Access Compliance Report

Public Rights-of-Way

(Pedestrian Signals)

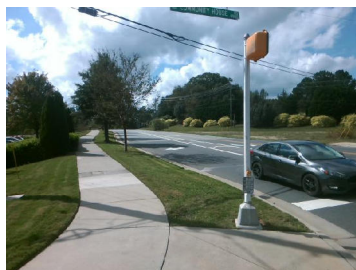
PROW/ADA: R404.2, R404.3, R406.2

Possible Solutions: Provide Push Button Extension. Remove and Replace Clear Space.
